1 Red Line Revision November 24, 2010

MD 6 AND WASHINGTON AVENUE

LAPLATA, MARYLAND

TRAFFIC SIGNAL PLAN

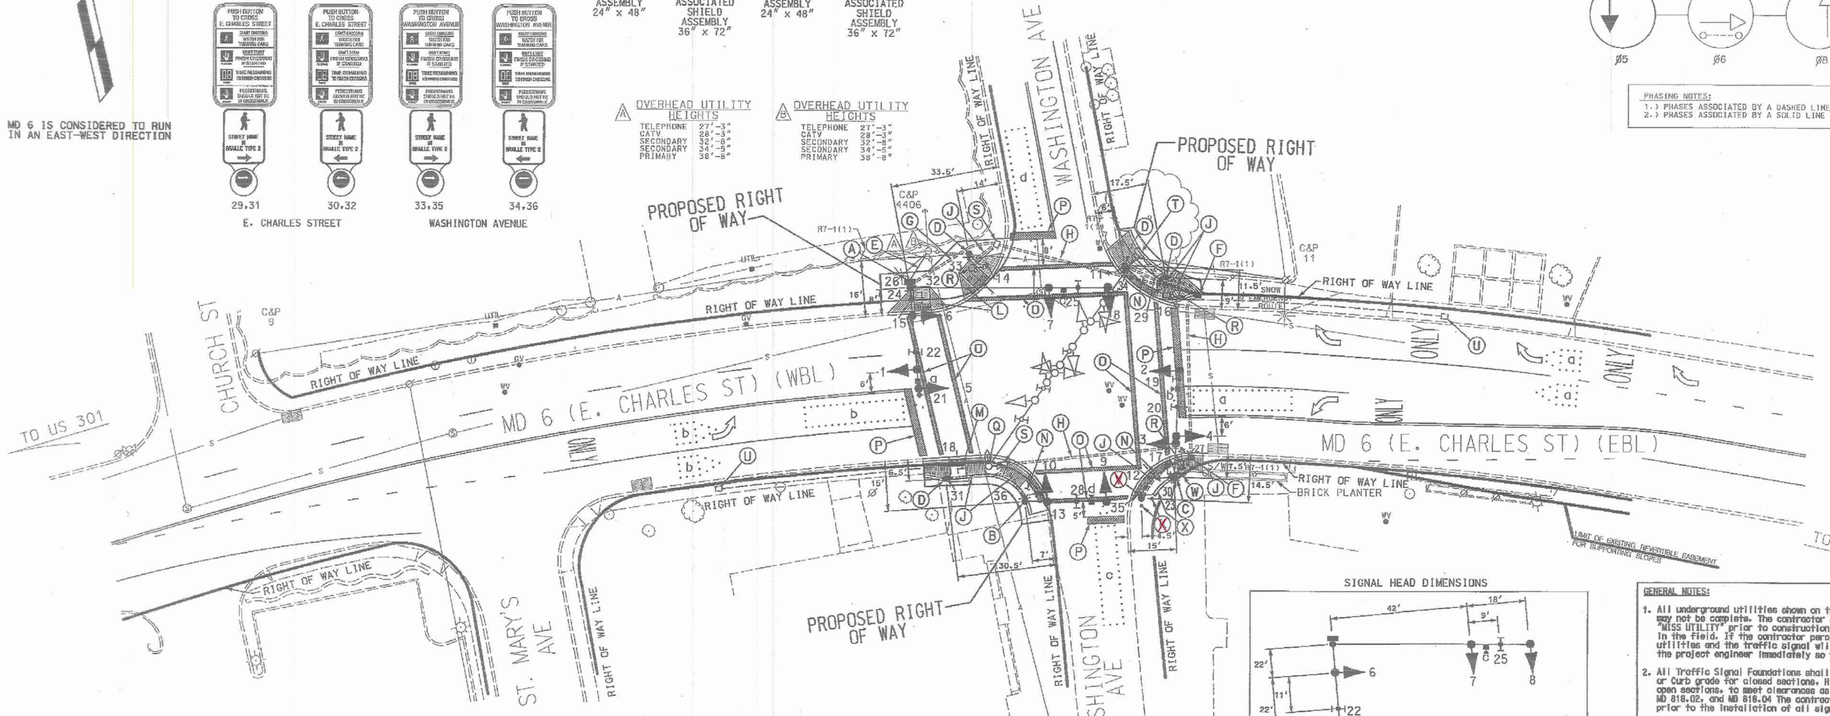
1 A. Install 27' steel pole with 32'/60' twin mast arms, traffic signal heads signs, countdown pedestrian signal head, pole mounted shield assemblies, APS pushbutton with pedestrian education sign (R10-3(1), Pole mounted Cabinet with controller and video detection camera. (Note: 2-3" 90° polyvinyl chloride (Schedule 80) bend. and 4" LB. for pole mounted cabinet.) control and distribution equipment

1 K. Install 4" galvanized steel mast filler with concrete as shown.

1 V. Install 5' 18" breakaway coupling foundation STD No. 801.01-01) pedestal pole with APS pushbutton and pedestrian education sign. (Notes 1-3" 90° polyvinyl chloride (Schedule 80 bend).

Both push buttons shall be installed on the mast arm pole in the southeast corner
